DRP ADVICE 9.1

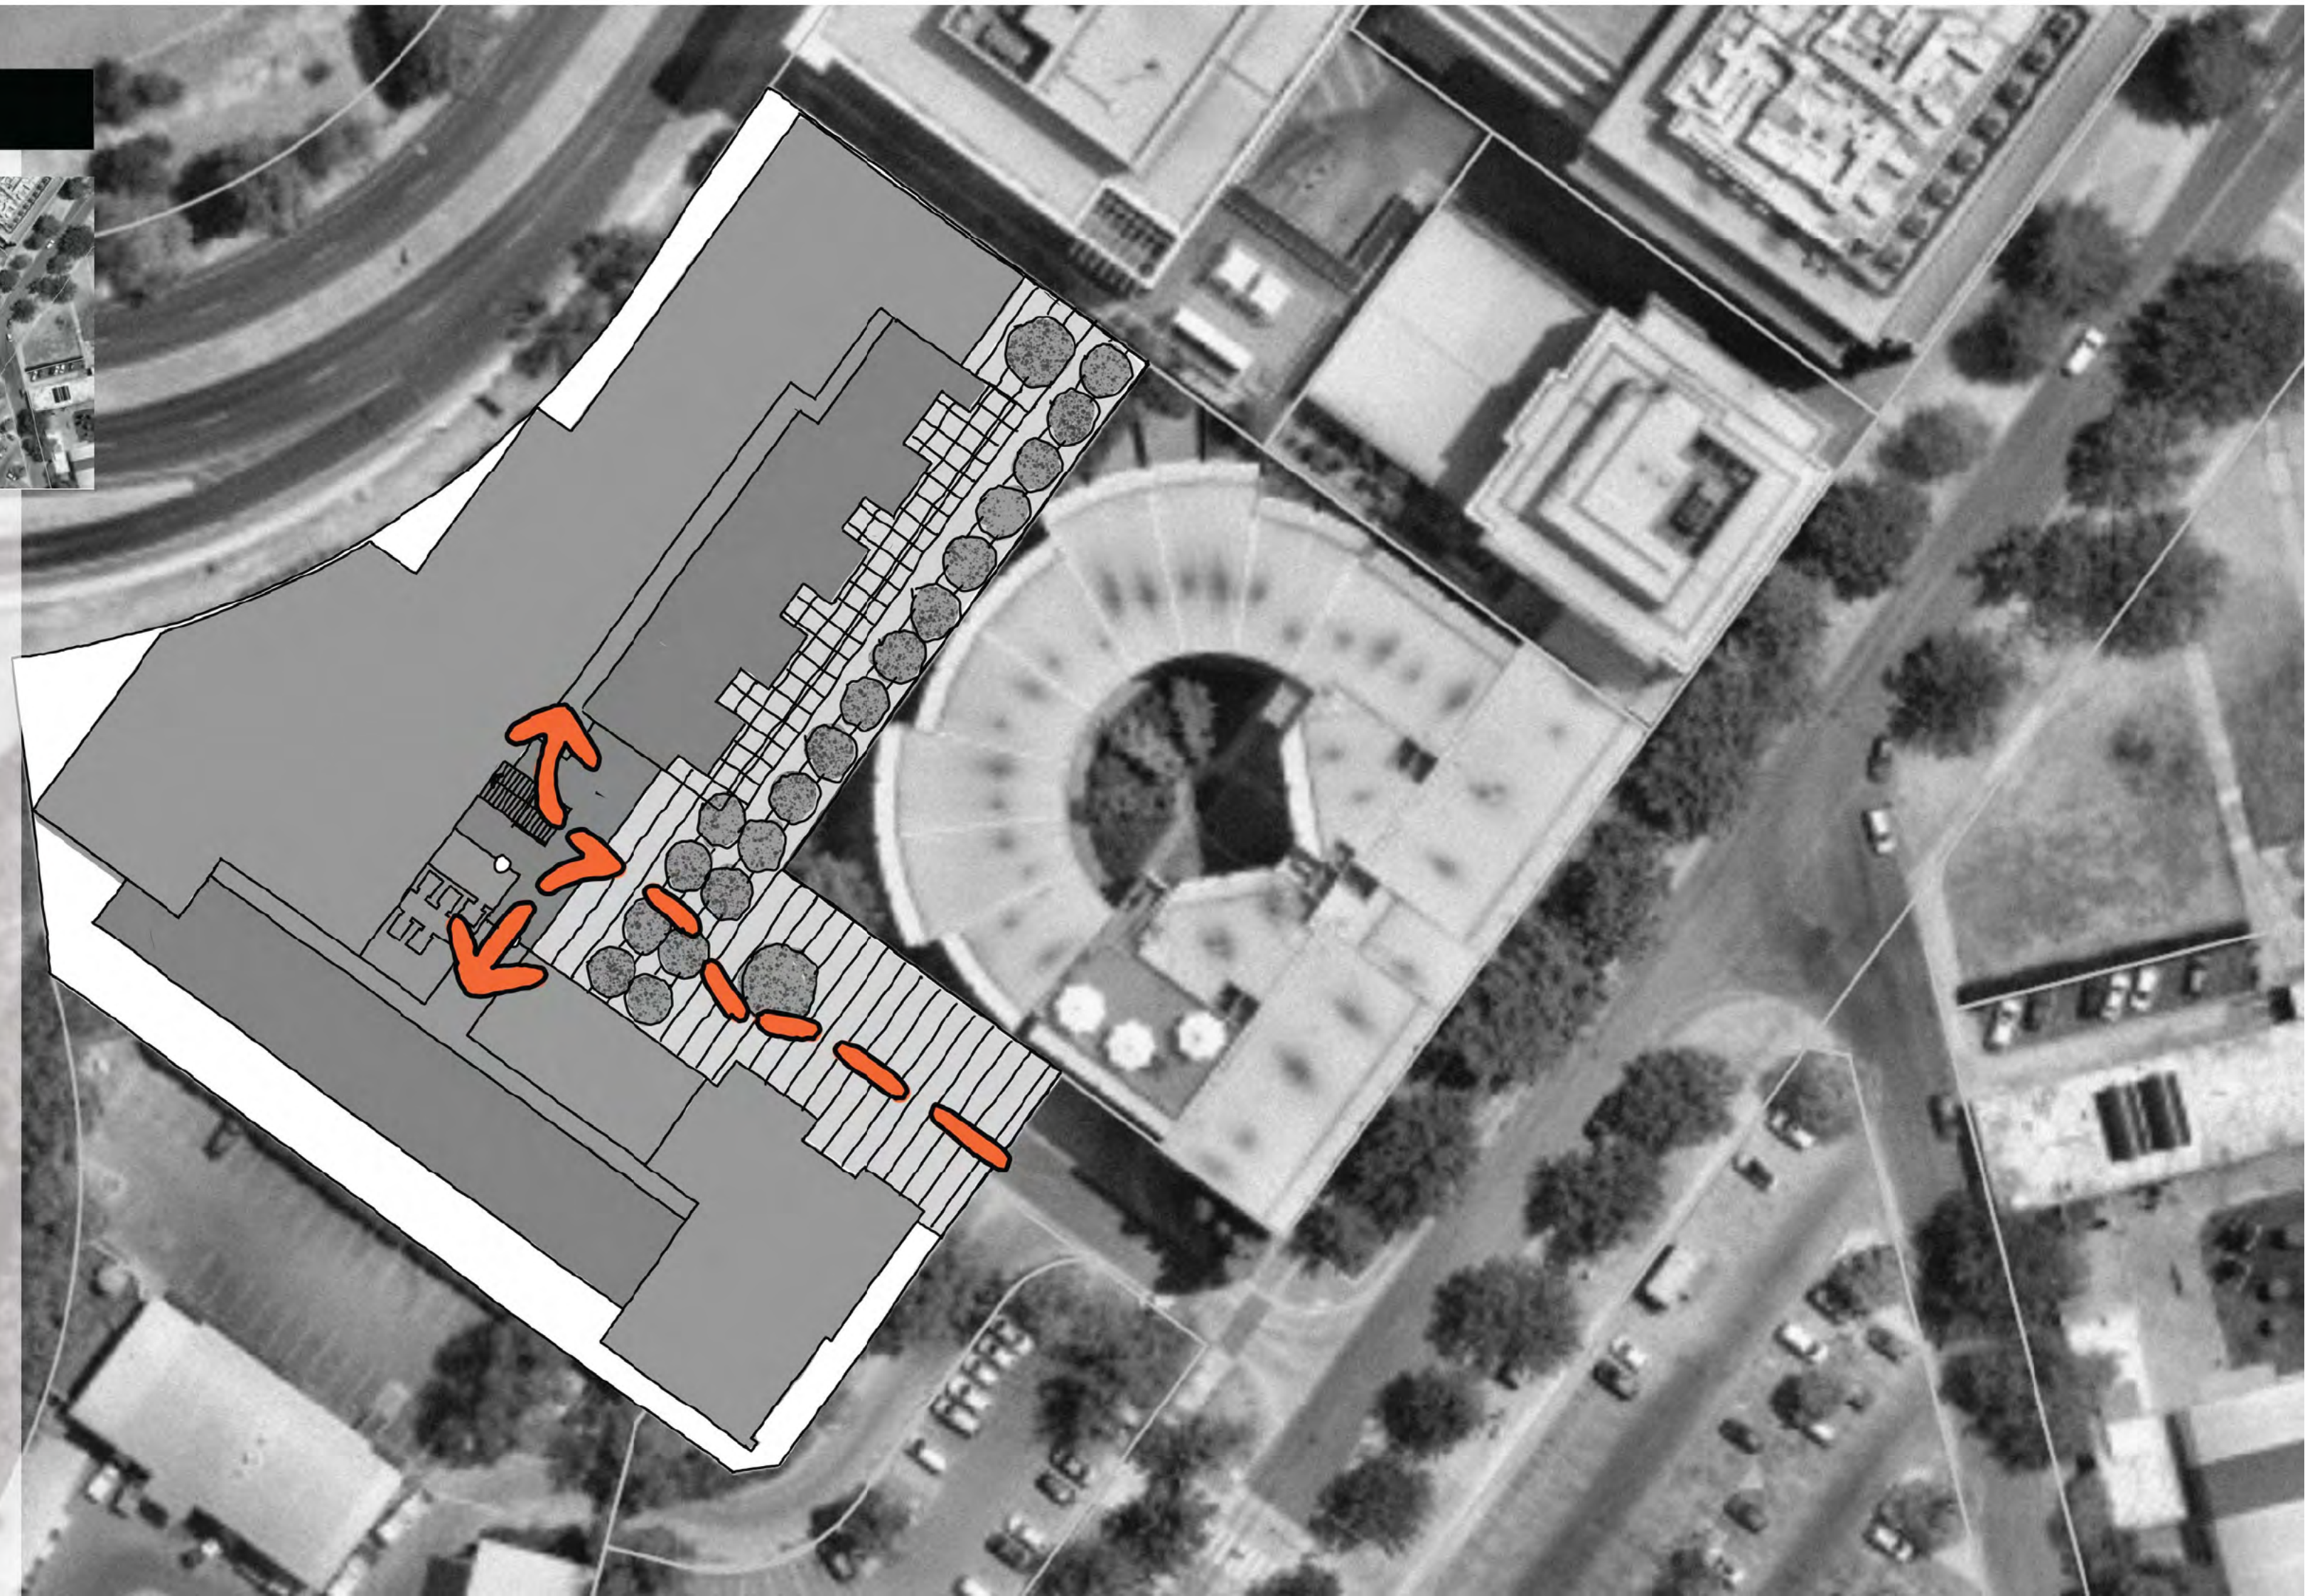
A pedestrian connection from London Circuit to Allara Street through the proposed development is supported by the Panel, however, the Panel considers that further exploration of how this connection will be activated and will operate as a shared accessway is still required. As such the Panel requests that the proponent prepares and presents further analysis of the public and private functionality of this pathway and their relationship to the adjacent spaces at the next design review session. This should include demonstration of how the proposal is anticipated to be experienced by the public (i.e. how it is made inviting for public use throughout the day and evening) and contributes to the public domain on site, as well as exploration of the resident experience such as community interaction, entry procession and arrival, recreation and privacy.

DRP ADVICE 9.1

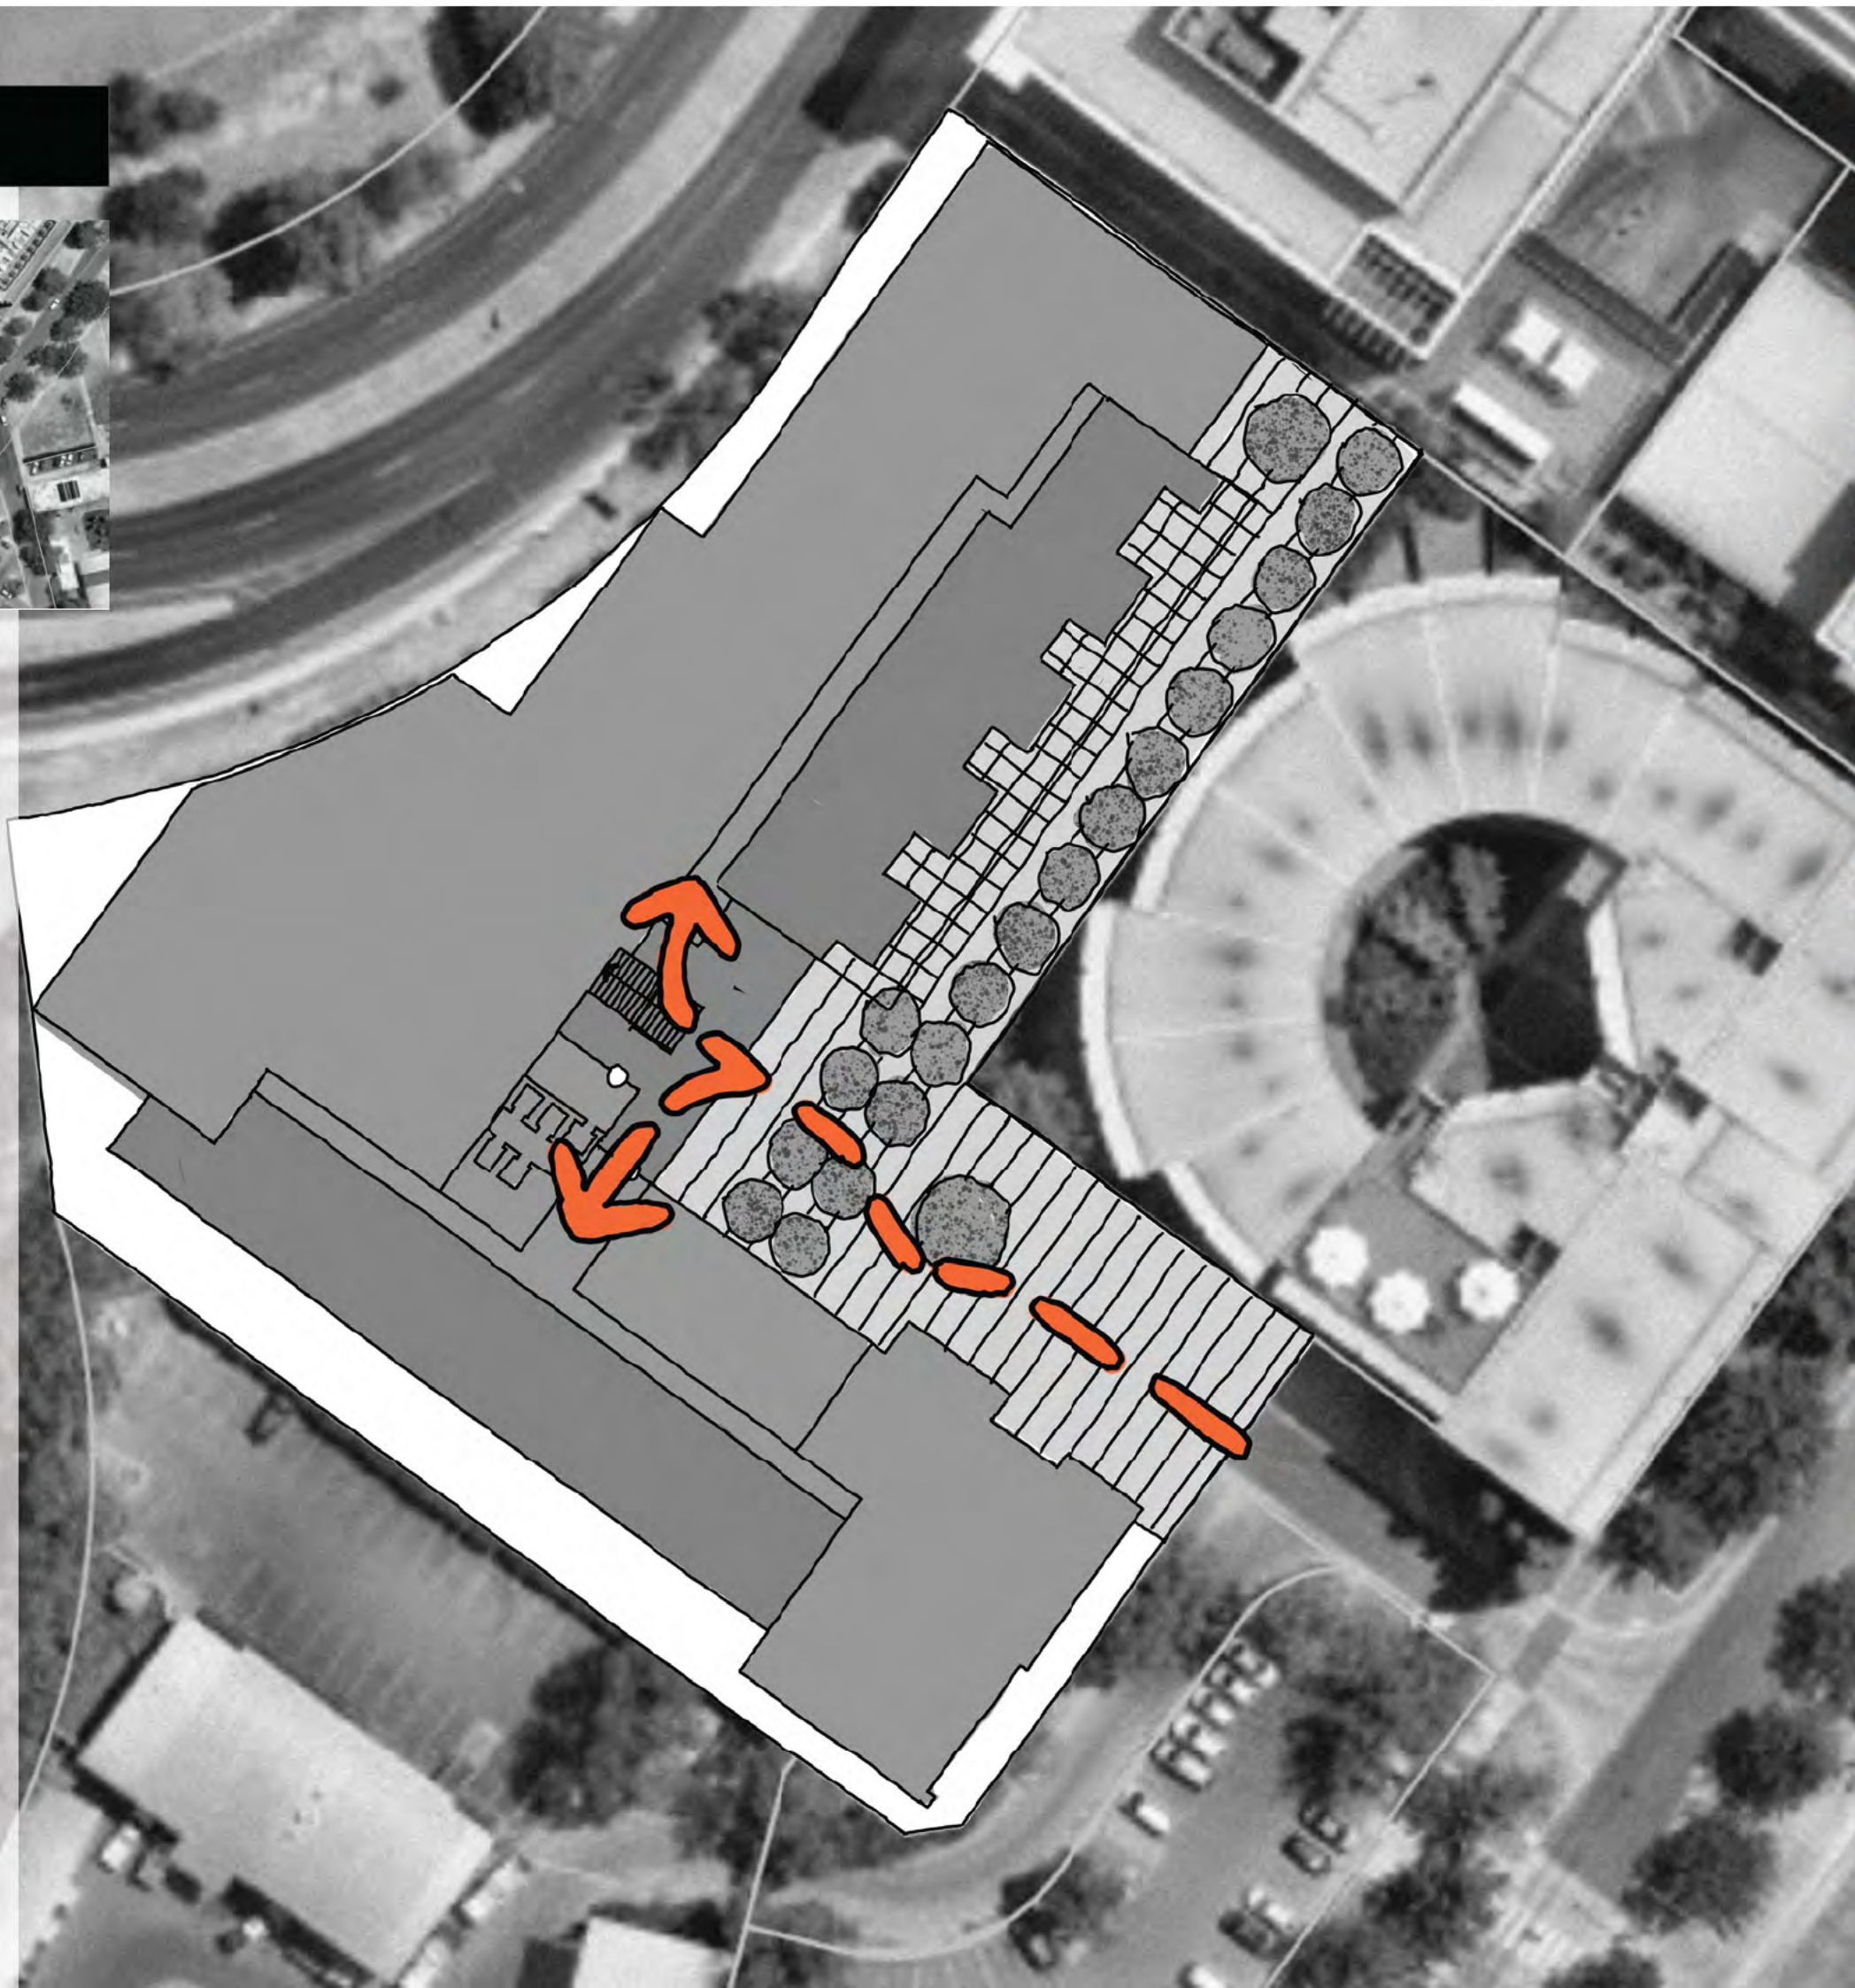
A pedestrian connection from London Circuit to Allara Street through the proposed development is supported by the Panel, however, the Panel considers that further exploration of how this connection will be activated and will operate as a shared accessway is still required. As such the Panel requests that the proponent prepares and presents further analysis of the public and private functionality of this pathway and their relationship to the adjacent spaces at the next design review session. This should include demonstration of how the proposal is anticipated to be experienced by the public (i.e. how it is made inviting for public use throughout the day and evening) and contributes to the public domain on site, as well as exploration of the resident experience such as community interaction, entry procession and arrival, recreation and privacy.

DRP ADVICE 10.1

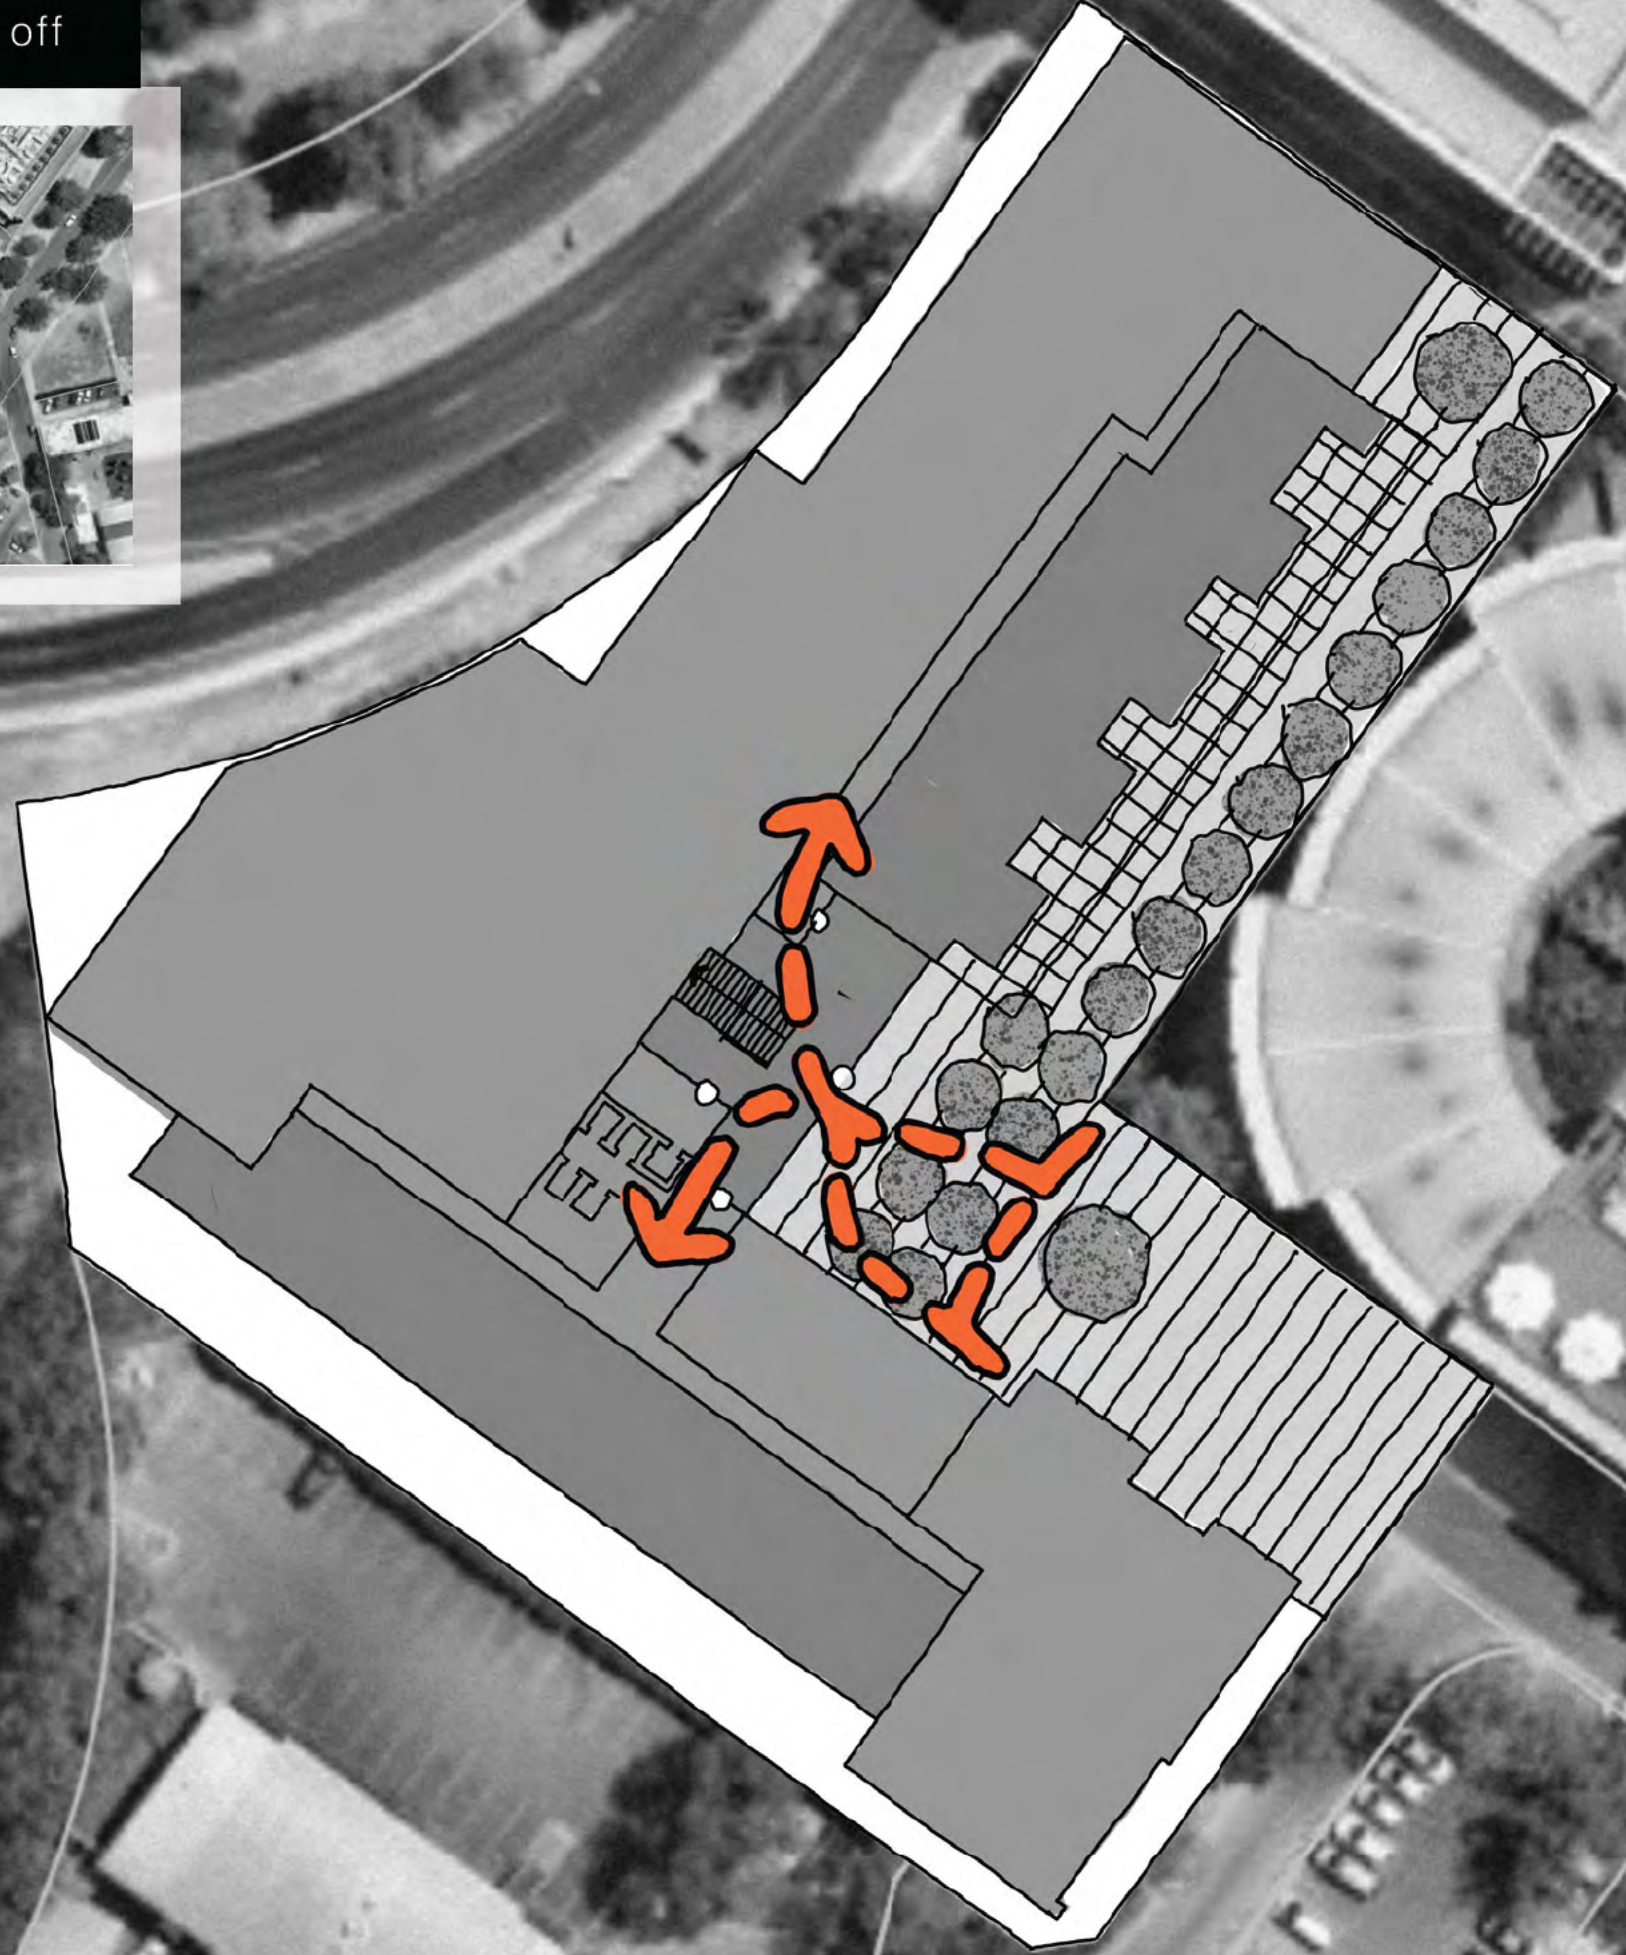
The Panel notes that the materiality of the proposal was not discussed in detail at the design review session however, the Panel considered the current extensive glazed façade presented to be incongruous with the setting of a proposed development within the National Triangle. Given the early design phase of the proposal, the Panel encourages the proponent team to develop a strong vision for the proposal which is 'of place' and consider implementing a materiality and architectural expression appropriate to the residential use as well as the civic nature and setting of the development.
